ADDENDUM NO. 1

TERRY CARGIL RESERVOIR

LACEY CONTRACT NO. PW 2019-32

SHEET
S-4
23 of 62

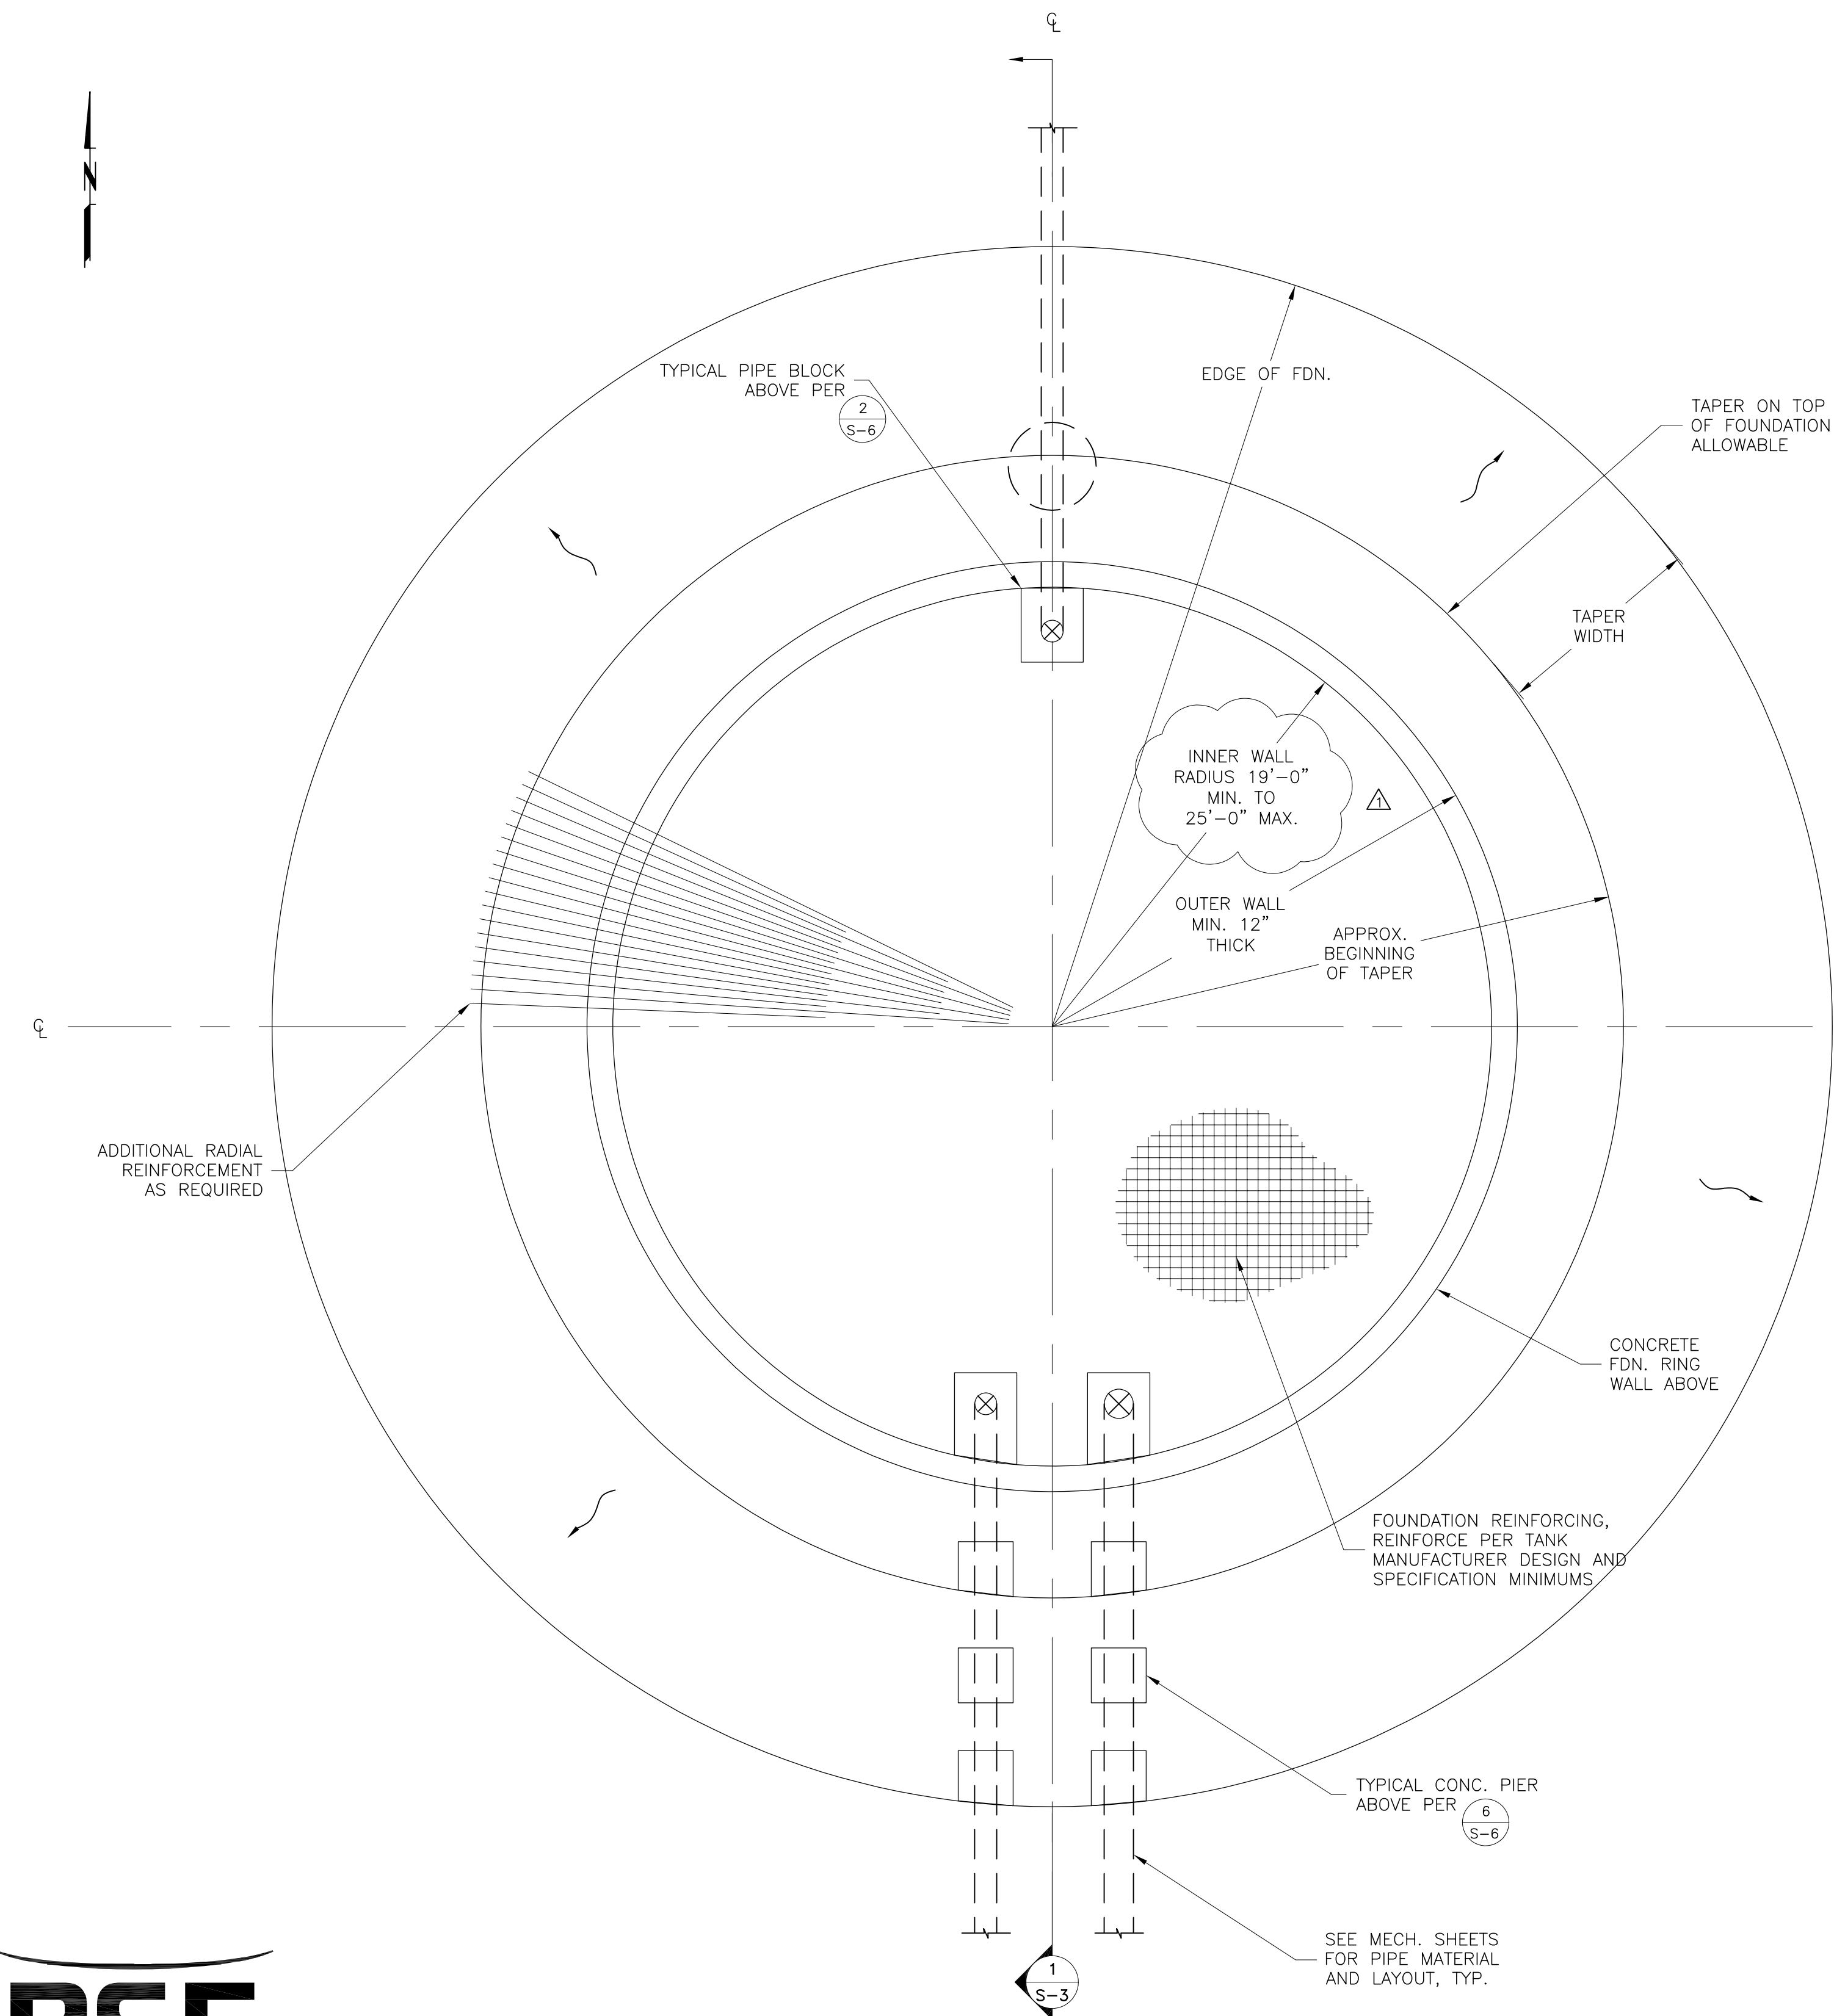
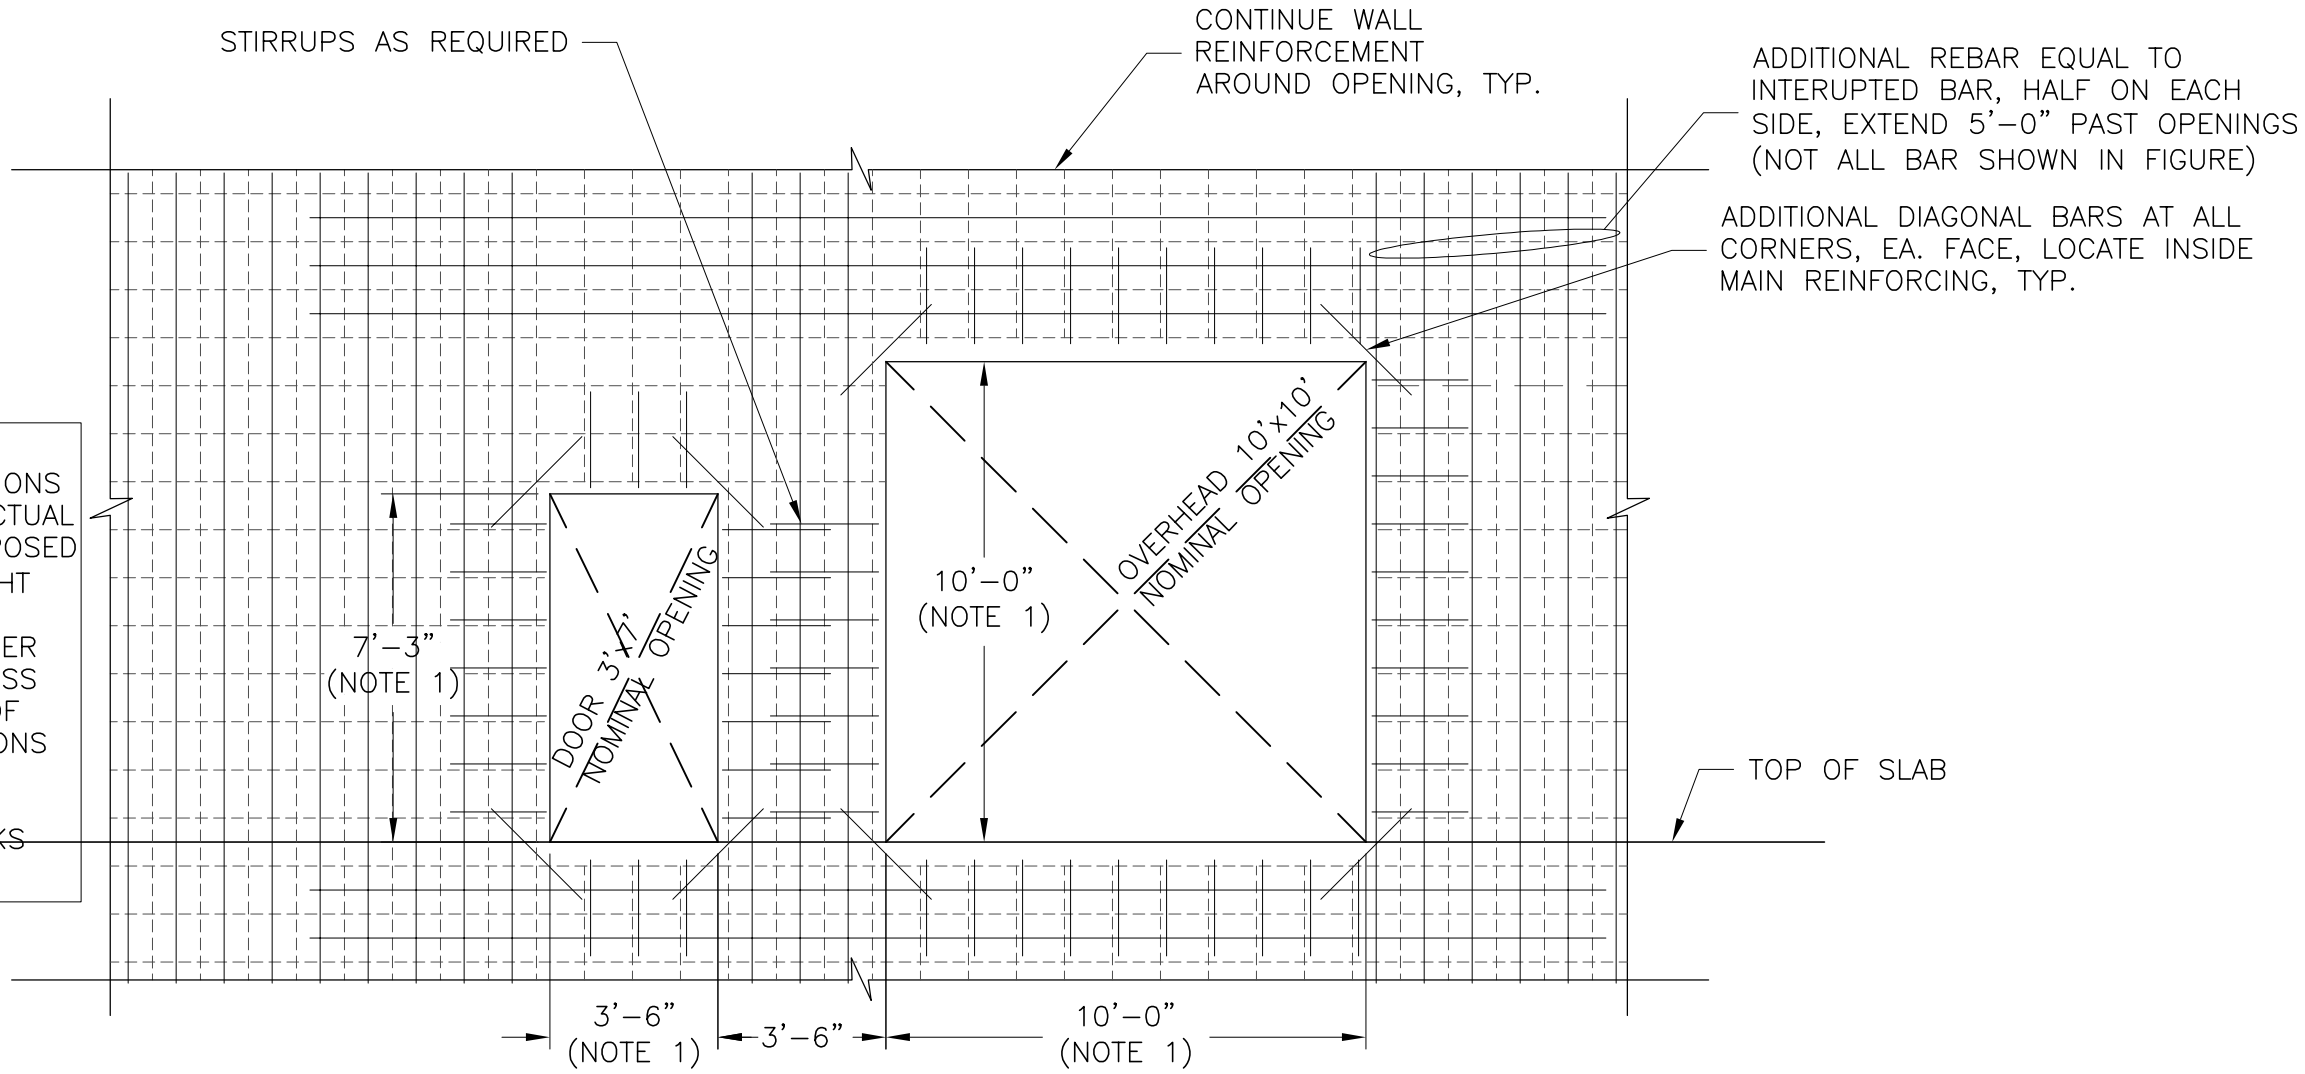
- 1) *The revisions include changes to notes related to the reservoir radii.*
Delete Sheet S-4 / Page 24 of 62 and replace it with the new page as attached.

SHEET
S-5
24 of 62

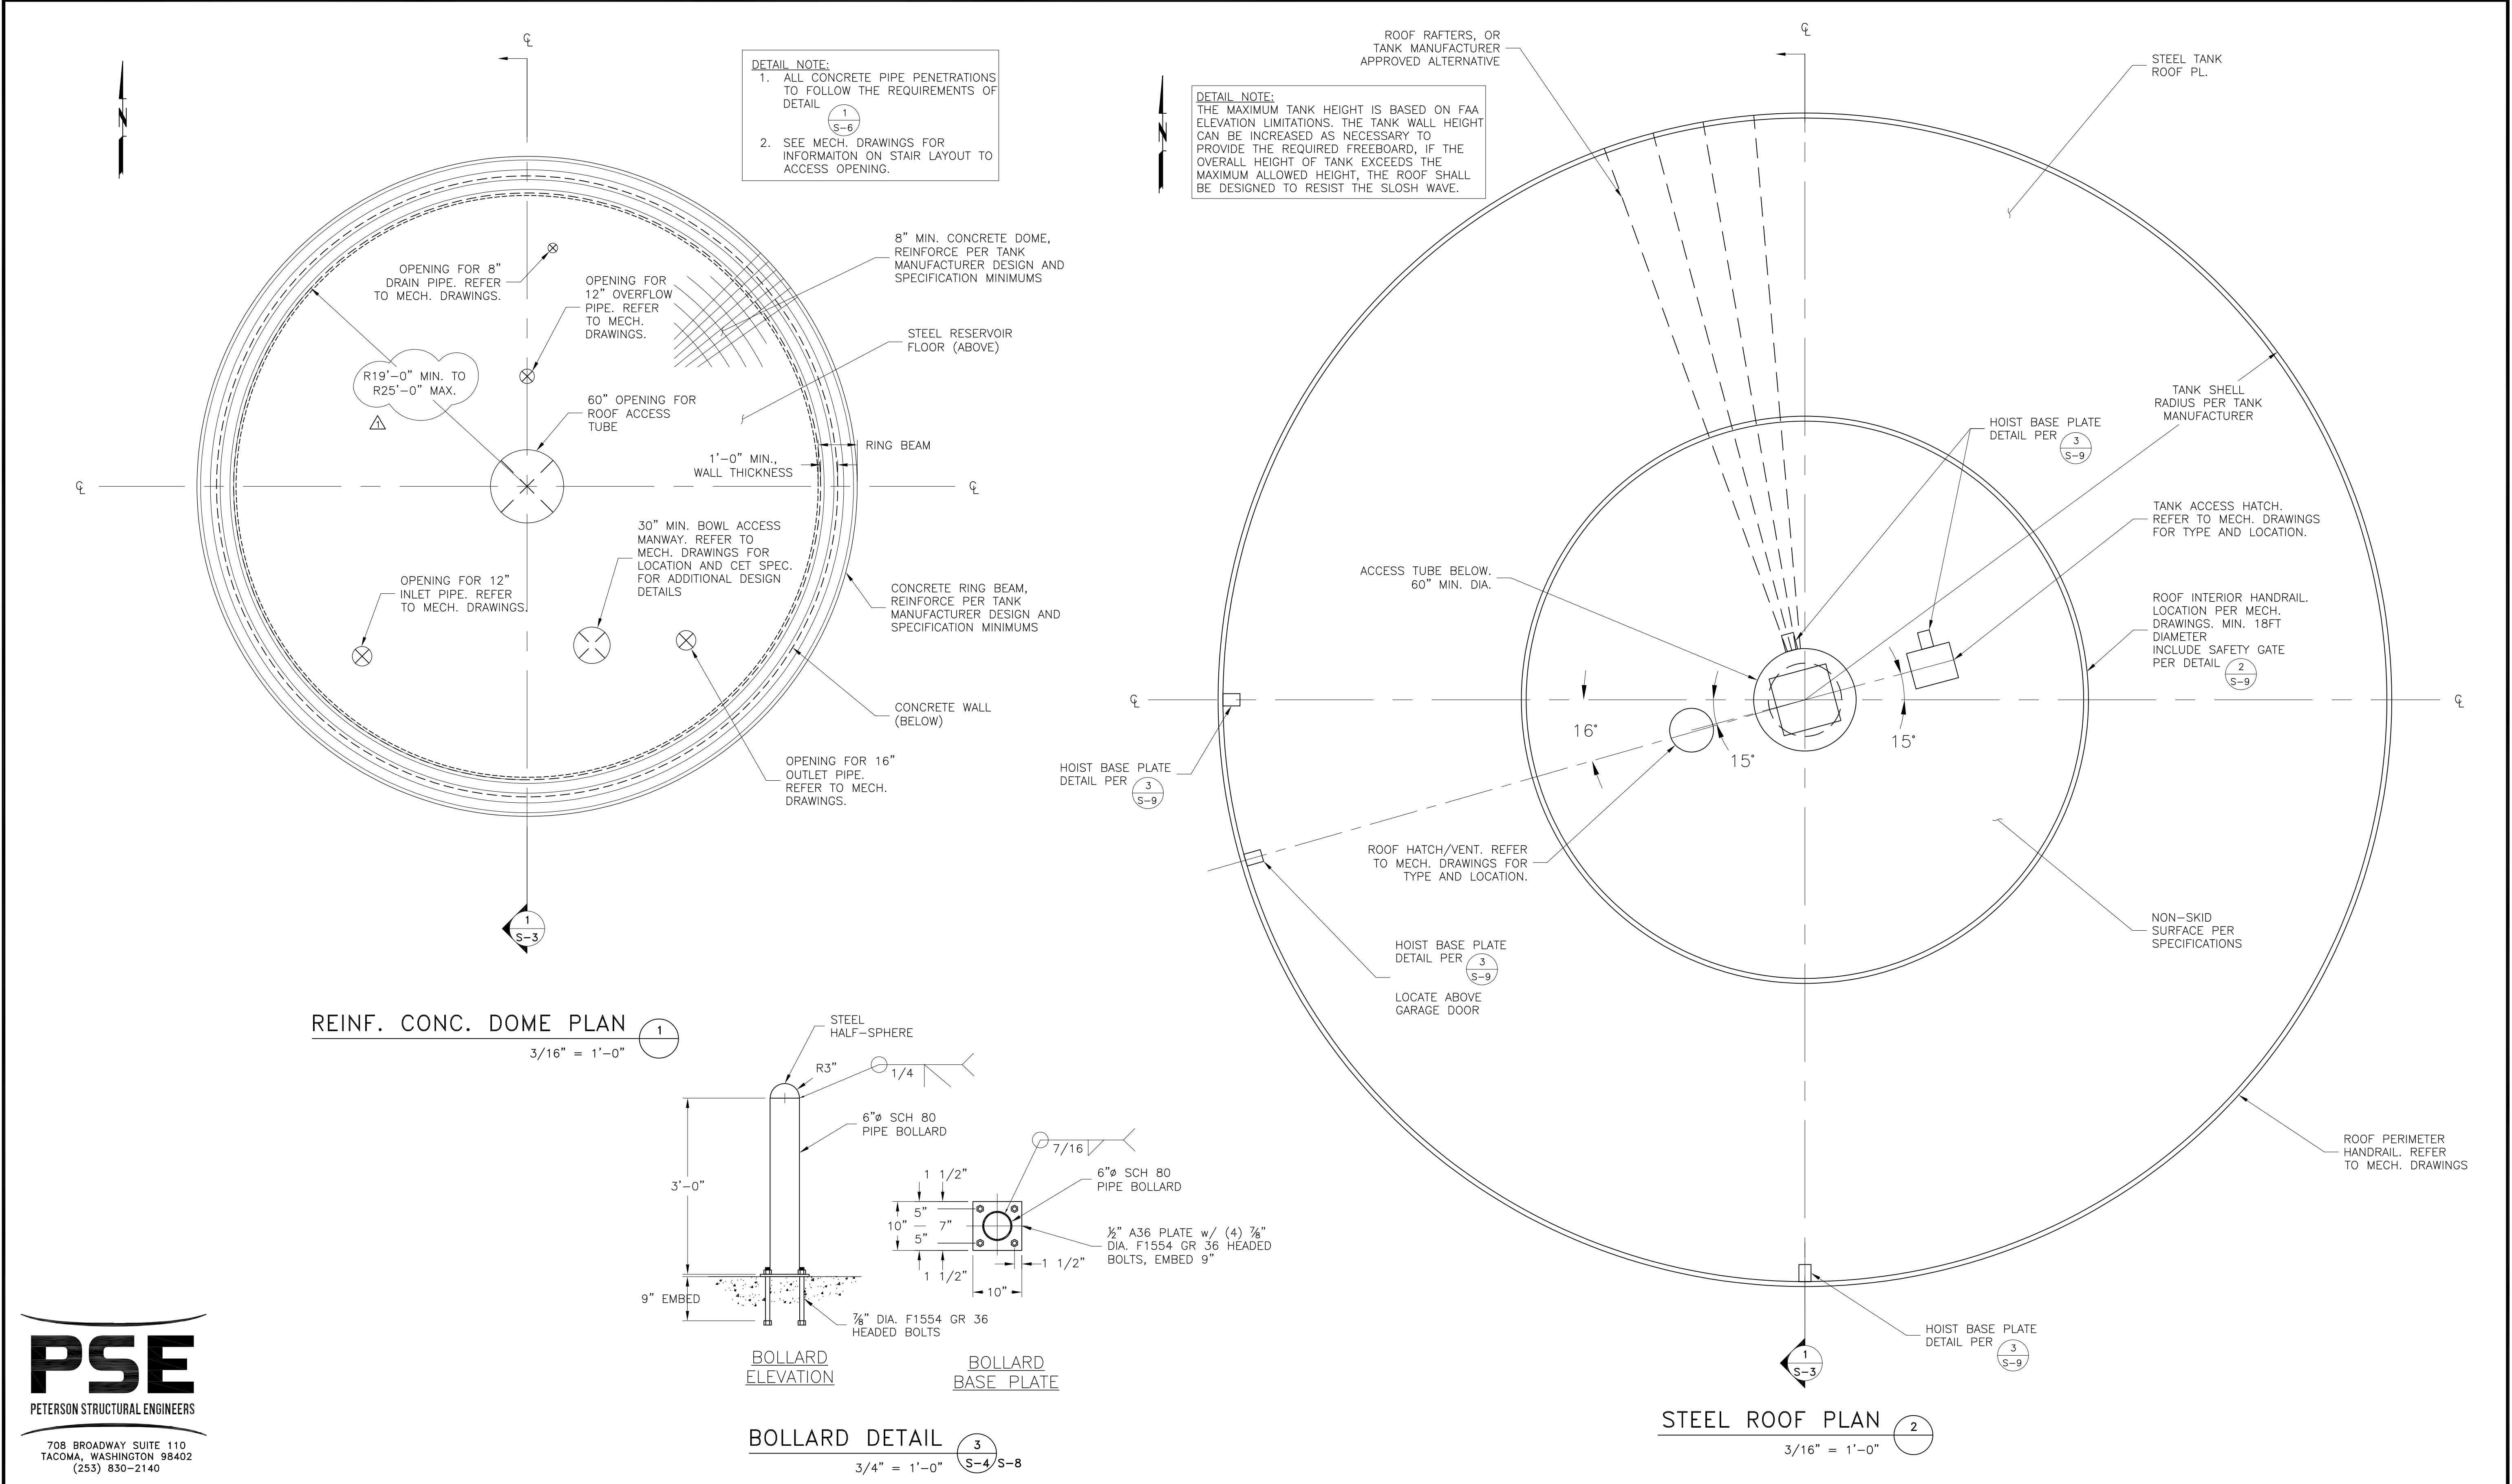
- 1) *The revisions include changes to notes related to the reservoir radius.*
Delete Sheet S-5 / Page 25 of 62 and replace it with the new page as attached.
